APPROVED MINUTES OF THE MEETING

February 18, 2010

February 18, 2010 **Project:** **Bell Street Park**

Phase: Concept Design

Figure 2: Measured Movement Plan

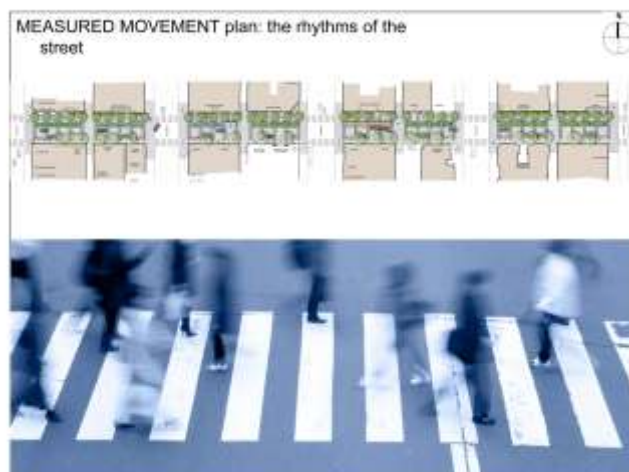
- Consider the spaces when they are empty, particularly with the measured movement scheme as it relies on people to activate the space. A simple palette gives a better and more flexible use of the space.

With the measured movement scheme, you are relying on activity to activate the street, what you are going to do when there is no enough activity.

Being honest about the place, when there is no people present, it might be sparse, so we are working with the parks department programming to come up with solutions. The waterscape will also help to bring in richness to the space.
